MANDATORY SERVICE BULLETIN NO. MSB40-018/2

Autopilot.

BULLETIN NO: KC 140-M1
KC 140 Autopilot Computer

This conversion consists of changing the KC 140 application software, changing the unit part number, placing an M Tag on the unit serial tag, and updating the unit's Software Mod Tag.

Figure 1
Test Harness

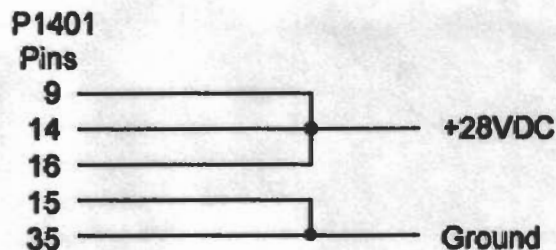
1. Build a test harness as shown in Figure 1 using the following parts. This test harness can be reused to program any number of KC 140 units according to this M bulletin.
 - A. 37-pin connector P/N 030-01175-0000
 - B. 37-pin hood P/N 030-02351-0023
 - C. 5 crimp sockets P/N 030-01157-0011
 - D. 2 screws P/N 089-06415-0006
 - E. Shop-supplied 22AWG wire

Figure 2
Location of P4 on the Main Board

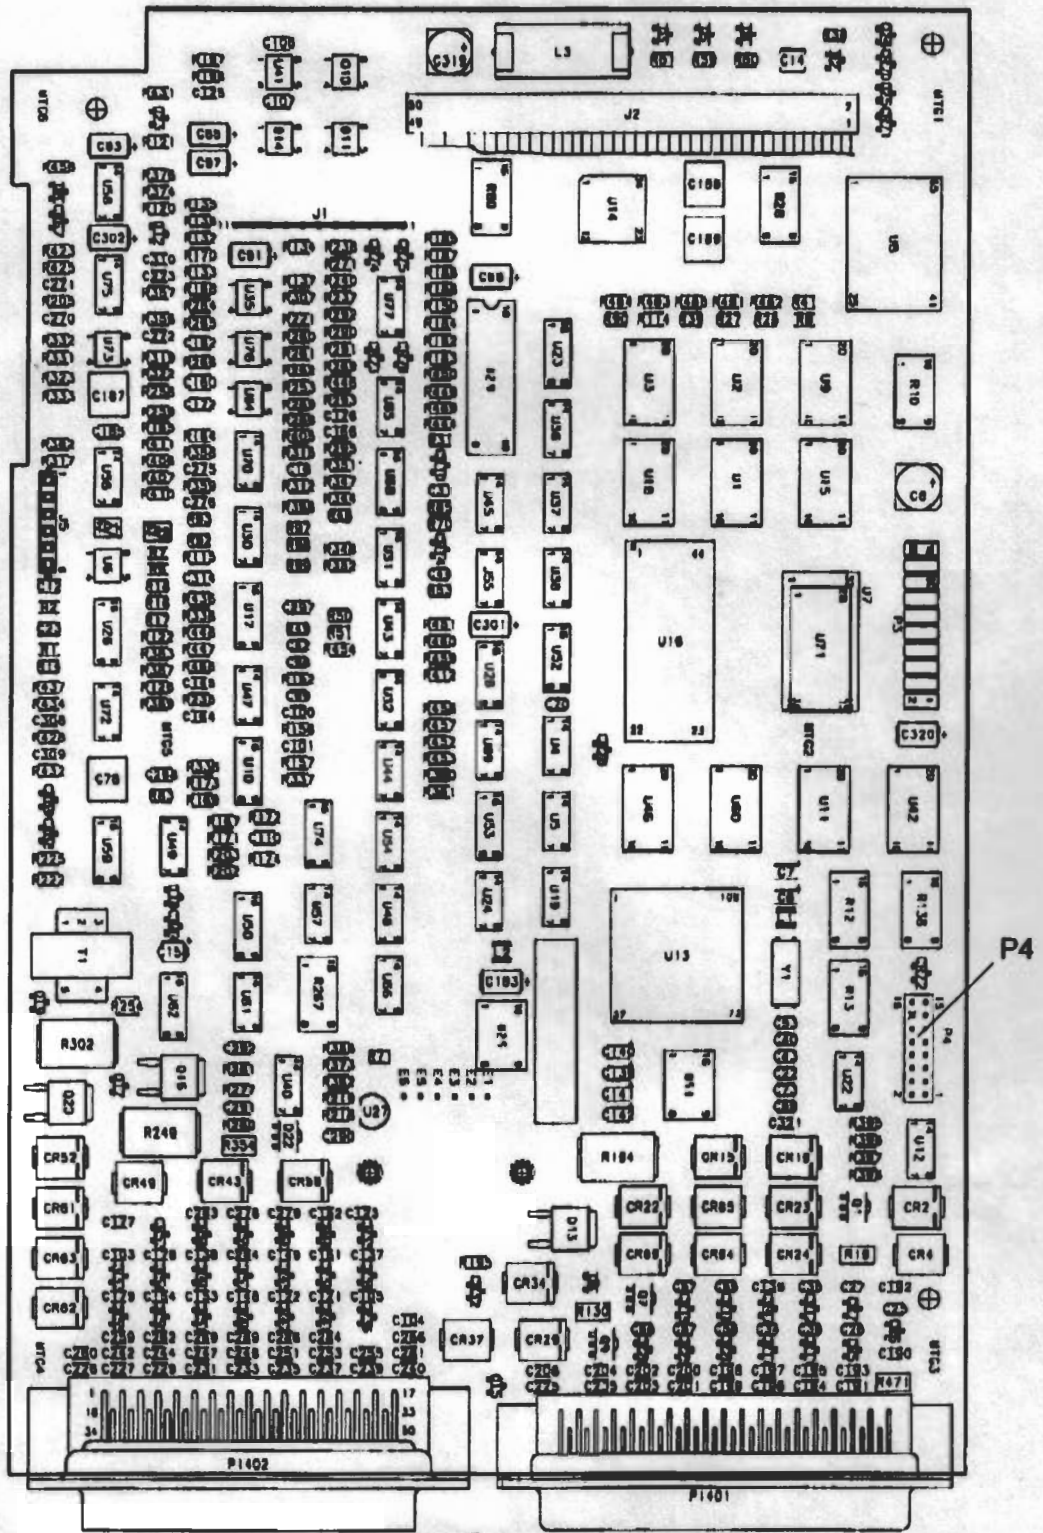
5. Connect the test harness from a 28-volt DC supply to J1401 on the KC 140.
6. Connect the ribbon cable from the Programming Interface Box to P4 on the Main Board. See Figure 2 for the location of P4.
